SUBJECT: ISSUES RAISED AT PUBLIC HEARING
NORTHEAST SECONDARY SCHOOL
Rezoning Reference #98-9

PURPOSE: To provide information relating to issues and concerns raised at the subject Public Hearing.

The Public Hearing for Bylaw 10778, Amendment Bylaw 34, 1998 (Rezoning Reference 98-9) was held on 1998 July 07. The purpose of this rezoning bylaw is to permit the development of a Secondary School at 8800 Eastlake Drive, on the north side of the Lougheed Highway between Gagliardi Way and Eastlake Drive.

Map I

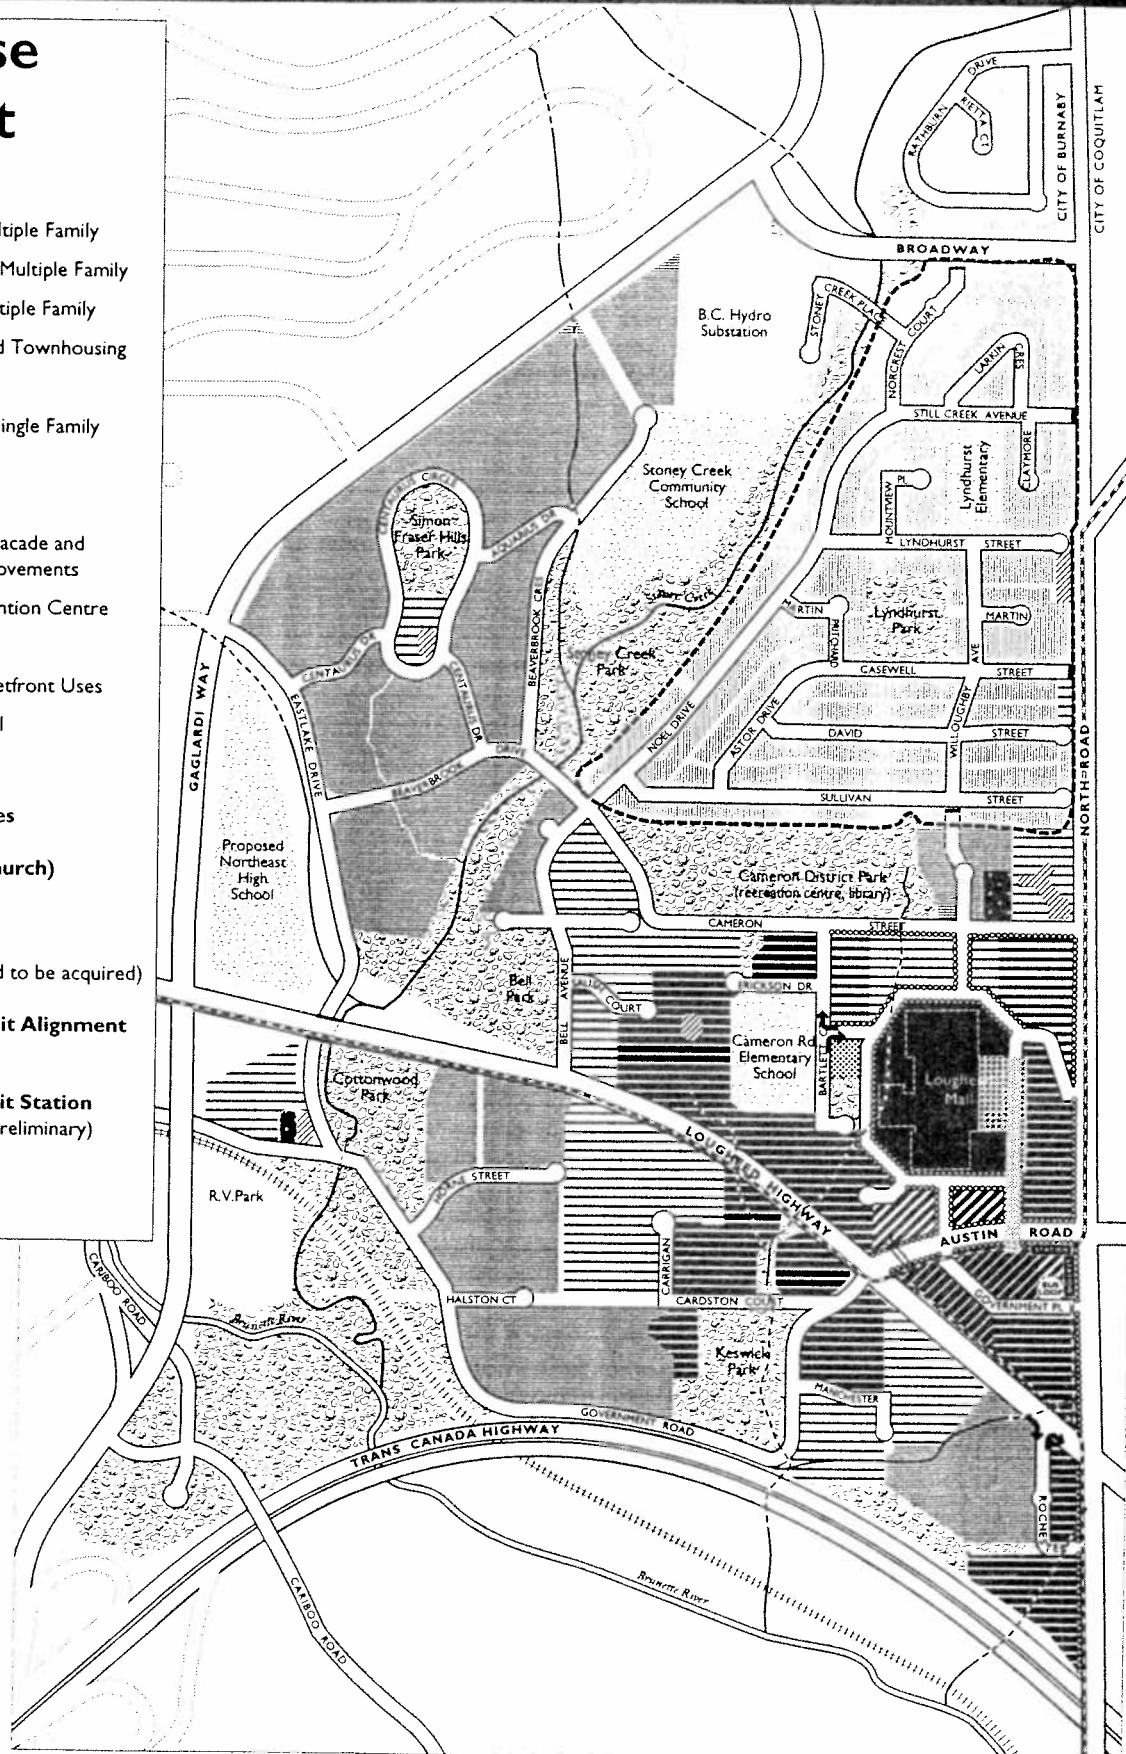
It was questioned whether the Lougheed Town Centre Plan includes the proposed school on the subject site.

One submission stated that the Lougheed Town Centre Maps, one of which was included in the report on the rezoning, "incorrectly show Eastlake Drive adjacent to the site as connecting to Government Road".

The proposed Northeast High School is clearly indicated on the maps (see *attached* Map #1 - Land Use Concept) included in the Lougheed Town Centre Plan prepared by the Lougheed Area Advisory Committee and adopted by Council on 1997 June 23. It was also shown on this site in the draft Plan illustrated on the approximately 7,800 coloured brochures distributed to households, businesses, non-resident owners, and other interested parties in the review area in 1997 April. The proposed school was not a focus for public comment in the response to this brochure distribution and to displays at the Lougheed Mall and the two open houses held in 1997 May.

The planned future extension of Eastlake Drive is an element of the adopted Lougheed Town Centre Plan, which recommends "extending Eastlake Drive under the Lougheed

Highway to Government Road to provide north-south access within the Town Centre, including access to the high school site." This extension is not being pursued in conjunction with development of the school. Instead a temporary turnaround is being constructed at the south end of Eastlake Drive.

8:00 - 9:00 A.M.
Existing and Future Traffic

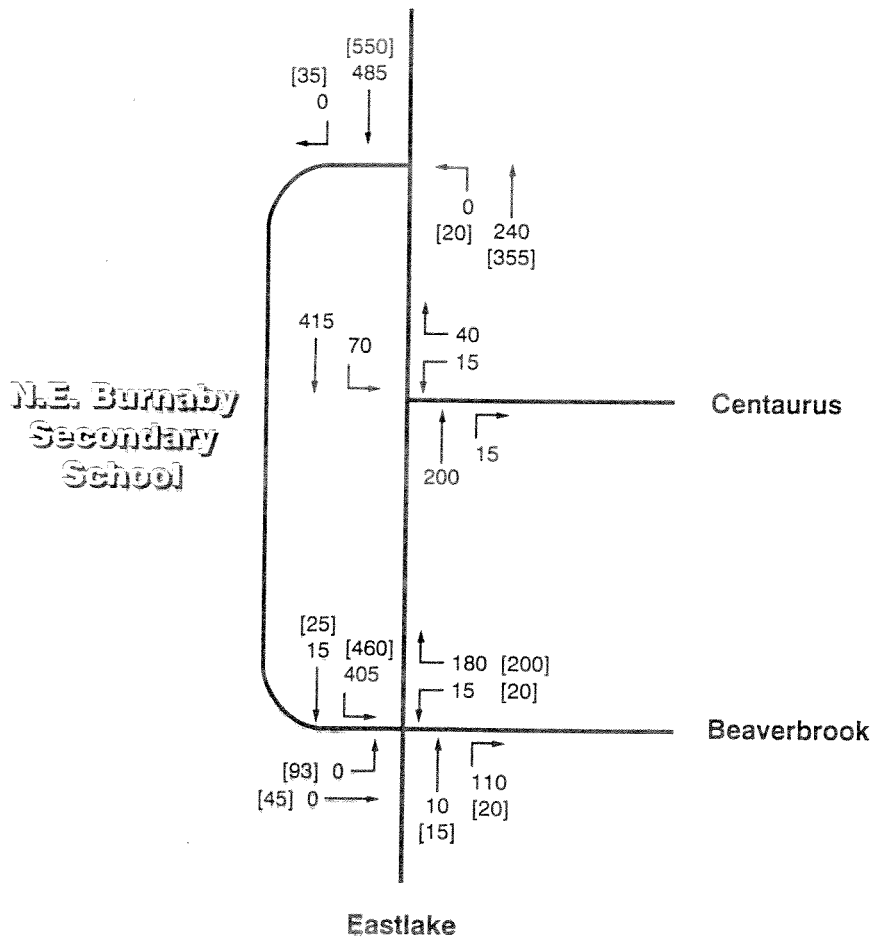
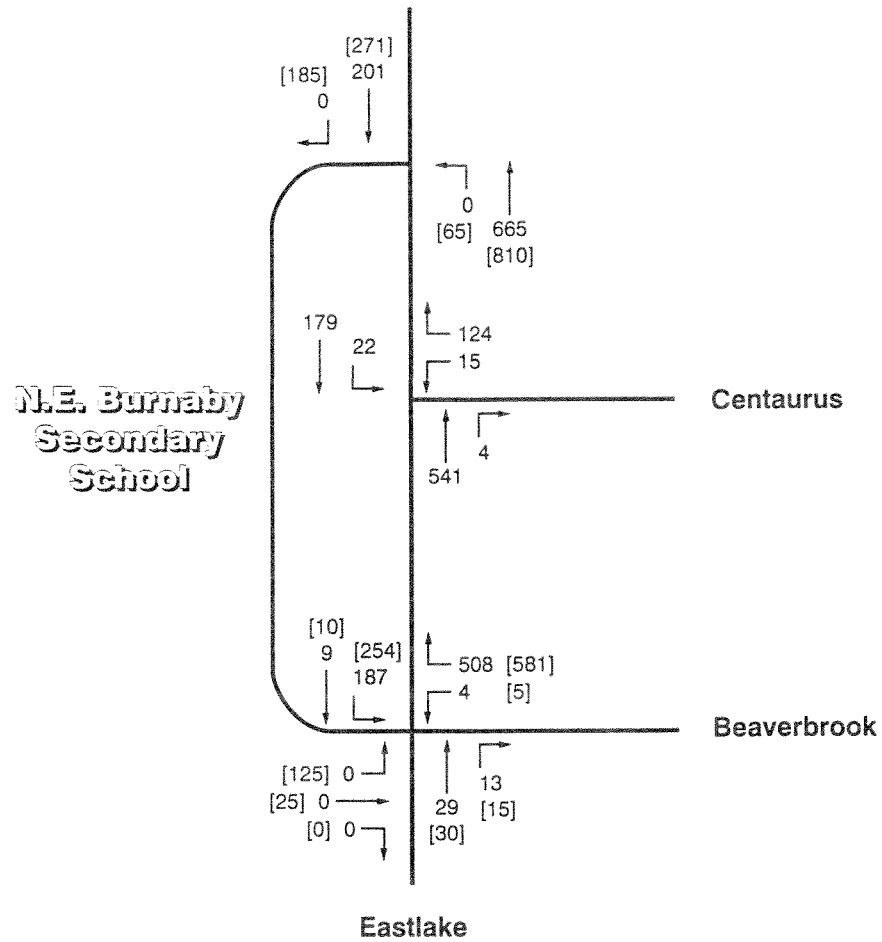
A number of people raised concerns regarding increased traffic volumes on the Lougheed Highway and Gaglardi Way, as well as increased traffic and congestion on Eastlake Drive.

The school's impact on existing traffic volumes on the Lougheed Highway and Gaglardi Way will be minimal. The transportation consultant estimates that the trips generated by the school in the 7:00 am to 9:00 am period will total 545 inbound and 340 outbound (both including 150 drop-off trips on-street). The *attached* Sketches #1 and #2 show existing and estimated future traffic volumes on Eastlake Drive related to the school. The consultant's intersection operation analysis concluded that the driveway intersection (north of Centaurus) will operate at a satisfactory level of service without any significant impact on Eastlake traffic, and that the reconfigured, signalized Eastlake/Beaverbrook intersection will have good operating conditions.
